MILLENNIUM TOWER

PERIMETER PILE UPGRADE

DBI Report: 301 Mission Voluntary Foundation Retrofit

Response to Supplement No. 188, the response dated July 25, 2019, to my press release

Figure 8 – Historical Settlement Data

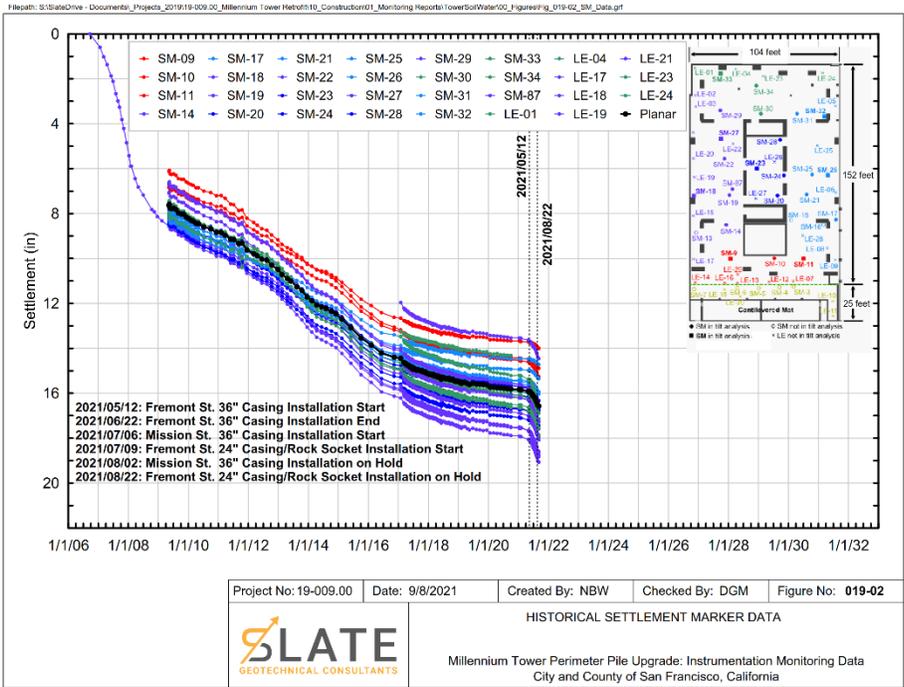
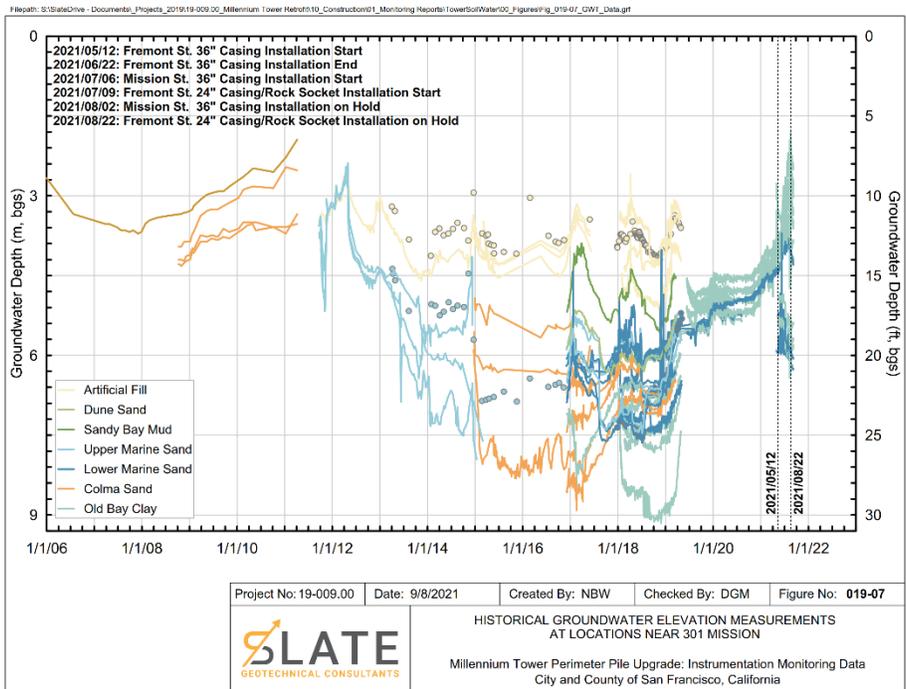
The first part of this response is very good, but the last part was not credible in 2019 and is even less credible today. Plots of the settlement and the variation in the elevation of the groundwater with time from the latest monitoring report are shown in Figures 8 and 9. Figures 8 and 9 strongly suggest that there was a small increase in the rate of settlement from 2015 to 2018 when the groundwater elevation was drawn down as a result of nearby construction activities and that the rate of settlement then slowed down from 2018 through 2019 as the groundwater elevation returned to normal. But to suggest that meant that the overall rate of settlement was slowing down is wishful thinking. By 2021, before the Perimeter Pile Upgrade commenced, the average rate of settlement over ten years was about ½ inch per year, with no real indication that it was slowing down. The reasons for this are not entirely clear but secondary consolidation / creep bearing capacity failure in the Old Bay Clays are widely believed to be the most likely cause. These are mechanisms that might go on for some decades.

While it is true that the design would accommodate reduction in the amount of jacking applied along the north and west sides, this was never the intent of the pile head detail. Rather, the intent of this detail was to allow jacking of additional force onto the piles if rebound resulted in reduction of the effective jacking force. We note, however, that since the settlement experienced to-date is due to consolidation of the underlying soils, as the building settles, the consolidating soils will ultimately become normally consolidated and the rate of settlement will naturally diminish significantly with time. In fact, this behavior is evident in review of settlement data collected over the past 18 months.

Figure 10 – Enhanced Settlement as a Result of PPU Installation

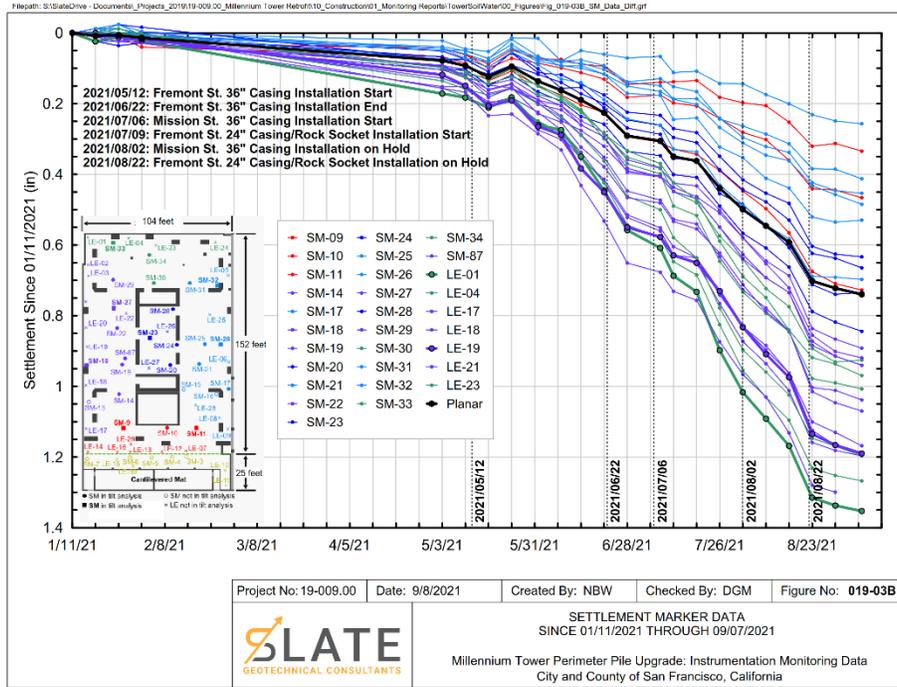
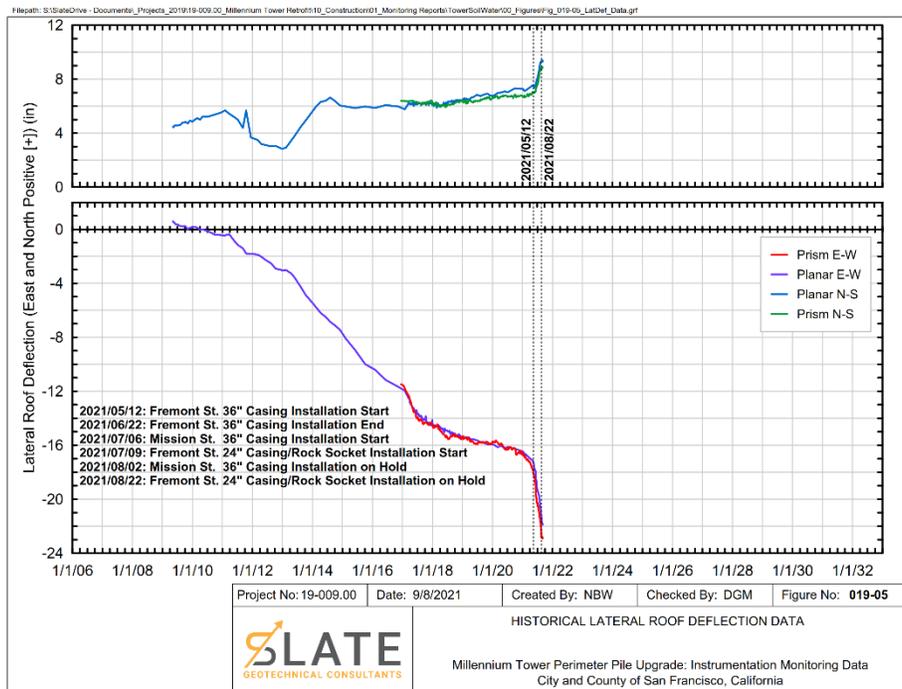
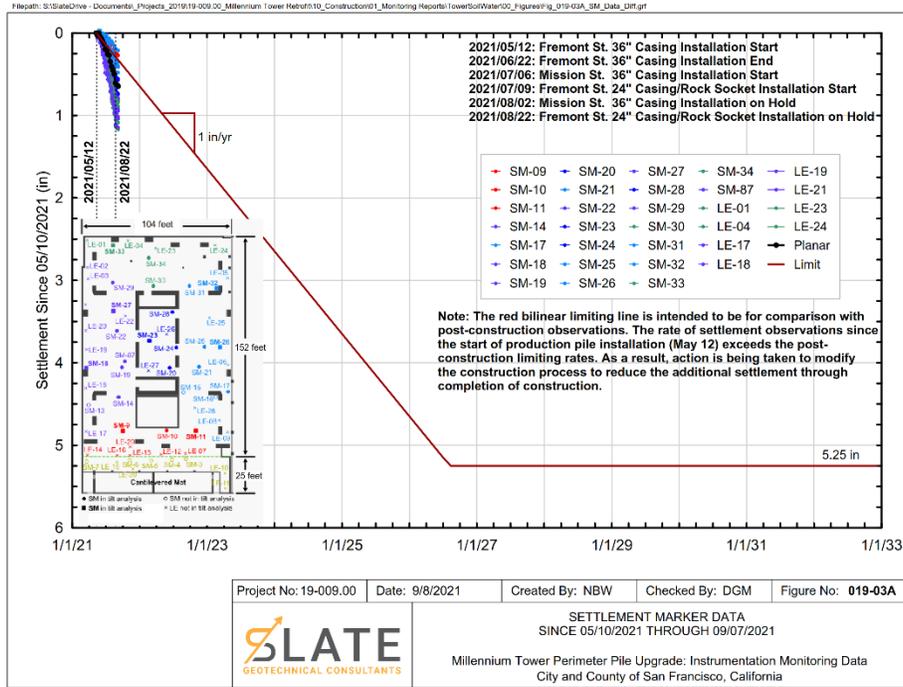
What has actually occurred is illustrated in the above three figures. Figure 10, taken from Monitoring Report 19, shows enhanced settlement starting in May 2021 and continuing settlement after both casing and pile installation was put on hold in August. A subsequent monitoring report shows some rebound after that, but more time is required to see how things settle down. Figure 11 shows the full history of lateral roof deflections. Because of the scale of the plot, this figure looks very scary, however, I believe that the design team is correct in saying that the enhanced rate of deflection is only temporary. The question is more why this was allowed to happen, why was disclosure delayed and what are the implications for the design team’s credibility on other issues?

Figure 12 shows the enhanced rate of settlement due to the PPU installation relative to Slate’s prediction of future settlements. This too looks kind of scary, but the comments in my previous paragraph still apply. Note that the red line in Figure 12 is not Slate’s best estimate of future settlement but that their 1 inch per year is their estimated maximum rate of future settlement of the south and east portions of the perimeter mat. This is not inconsistent with my estimate of about ½ inch per year. But where we differ is that, according to Slate, the settlement magically stops in 2026. The load redistribution that will occur if the PPU is completed and some of the weight of the building is transferred to the new piles is uncertain, but my guess is that the contact pressures under the core
